Well Name: GOLD MEDAL	Well Location: T24N / R10W / SEC 31 / NESW / 36.268036 / -107.938553	County or Parish/State: SAN JUAN / NM
Well Number: 6	Type of Well: OIL WELL	Allottee or Tribe Name:
Lease Number: NMNM22044	Unit or CA Name:	Unit or CA Number:
US Well Number: 300452685200S1	Operator: DUGAN PRODUCTION CORPORATION

Type of Submission: Notice of Intent	Type of Action: Plug and Abandonment
Date Sundry Submitted: 02/11/2025	Time Sundry Submitted: 02:12
Date proposed operation will begin: 03/08/2025

Notice of Intent – Plug and Abandonment

Operator: Dugan Production Corporation
Lease: 30-045-26852
Well(s): Gold Medal 6, US Well # 30-045-26852
Location: NESW Sec 31 T24N R10W (San Juan County, NM)
Sundry Notice ID #: 2836414

Planned P & A Schematic

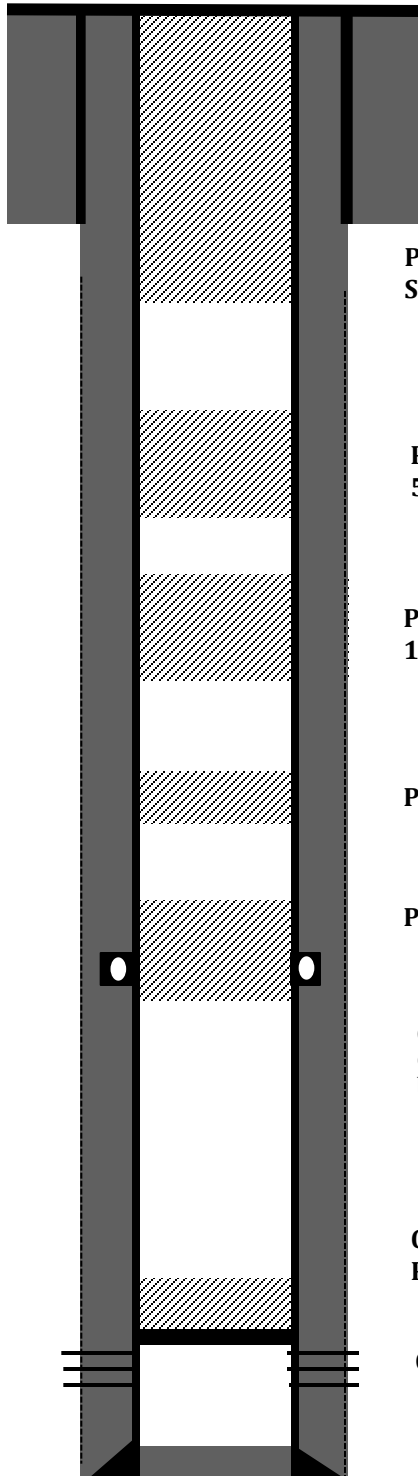
1. Plugging operations authorized are subject to the attached "General Requirements for Permanent Abandonment of Wells on Federal and Indian Lease."
2. The following modifications to your plugging program are to be made:
 - a. **Modify Plug 2: Move TOC to 3400' to cover the BLM geologist's pick for the Mancos.**
3. **Notification:** Farmington Office is to be notified at least 24 hours before the plugging operations commence at (505) 564 7750.

-Modify Plug 2: Move TOC to 3400' to cover the BLM geologist's pick for the Mancos.

Created By	Condition	Condition Date
mkuehling	NMOCD agrees with BLM picks for formation tops except for Fruitland= 595 and PC = 973 Adjust plugs to accommodate both agencies - Extend plug 1 to 50 feet below Gallup top - extend plug 5 to 495 - Notify NMOCD 24 hours prior to moving on - monitor string pressures daily report on subsequent - Submit all logs prior to subsequent	3/14/2025
